DEVELOPMENT REVIEW BOARD REPORT

CASE NUMBER/ PROJECT NAME	4-DR-2005#3 Taneko Tavern at The Borgata		
LOCATION	6166 N. Scottsdale Road		
REQUEST	Request approval of a site plan and elevations for construction of a new restaurant on an existing retail pad.		
OWNER	Westcor 602-953-6296	ENGINEER	N/A
ARCHITECT/ DESIGNER	P.F. Chang's China Bistro 480-888-3630	APPLICANT/ COORDINATOR	Scott Duffner Fancher Development 714-258-1808

Stipulations for Case: Taneko Tavern Case 4-DR-2005#3

DEVELOPMENT SITE PLAN

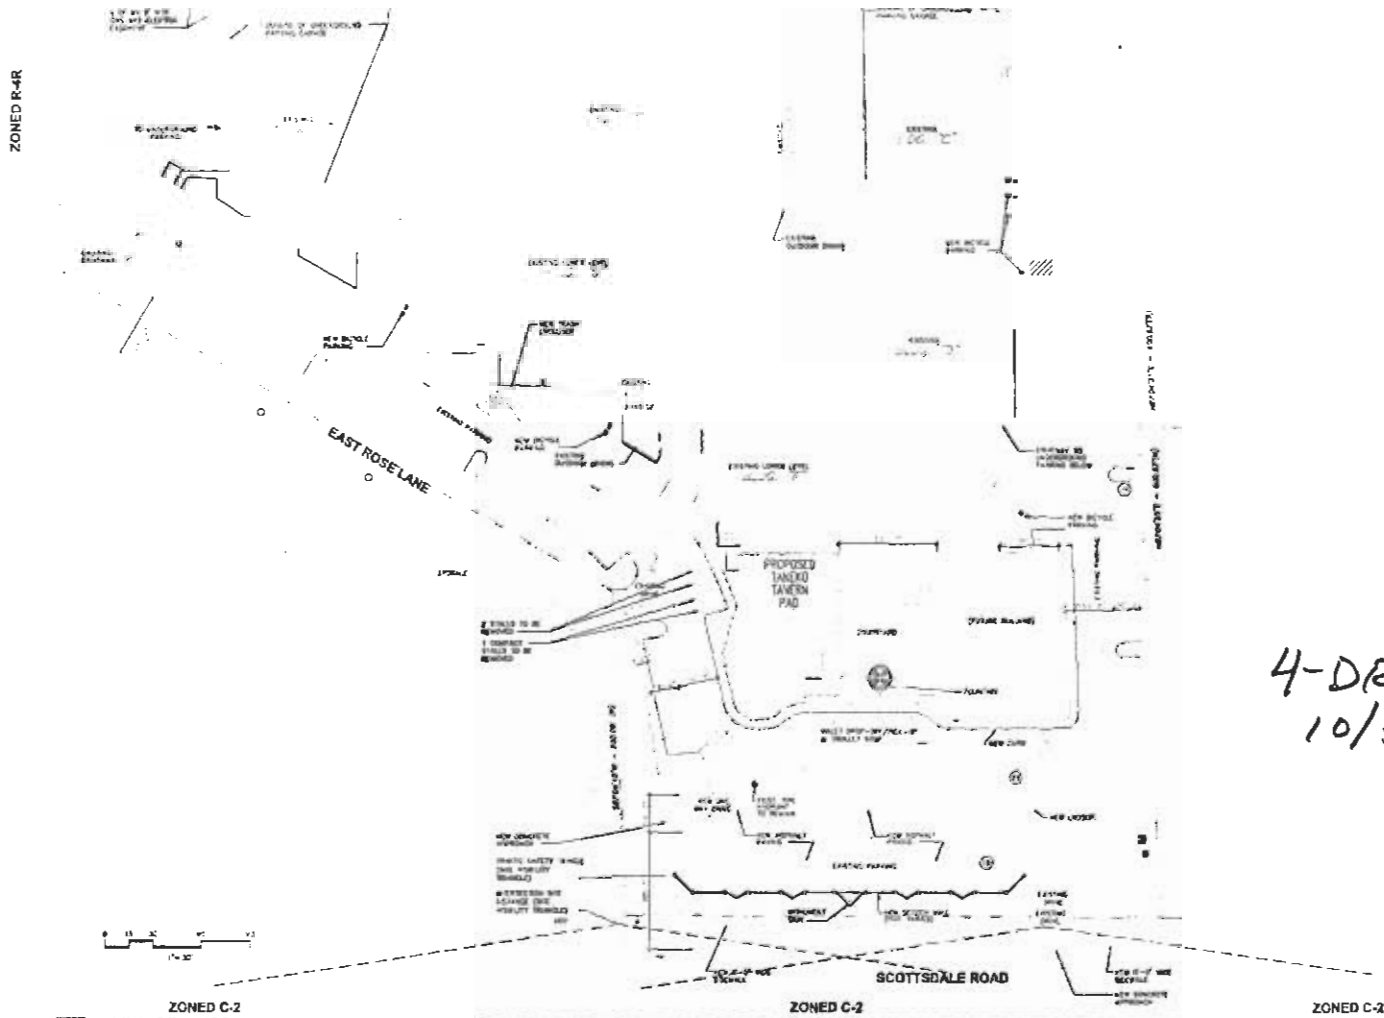
The proposed restaurant will occupy the southerly of the two restaurant pads, and is proposed to be located in essentially the same footprint as the site plan (June 9, 2005) indicated. The only modification is that the tenant, Taneko Tavern, needs additional floor area for equipment and is proposing to extend the structure to the south and remove 3 parking stalls along the southeasterly portion of the restaurant pad. This does not impact the overall site development standards and zoning provisions, and the project still conforms will all zoning requirements. The remainder of the proposed restaurant structure is compatible with the previously approved site plan, and includes the features the Development Review Board was most concerned about at the June 9, 2005 hearing:

Staff has analyzed these issues and finds that the proposed structure meets the spirit and intent of the Board’s discussion on both June 9th, 2005 and at the two most recent study sessions where the proposed project was discussed. The project has pedestrian connections in the places where they were approved as part of the Development Review Board approval for the overall site plan, the architecture is in keeping with the overall form and function of the Borgata development, and the patio area is in the location as shown on the approve site plan.
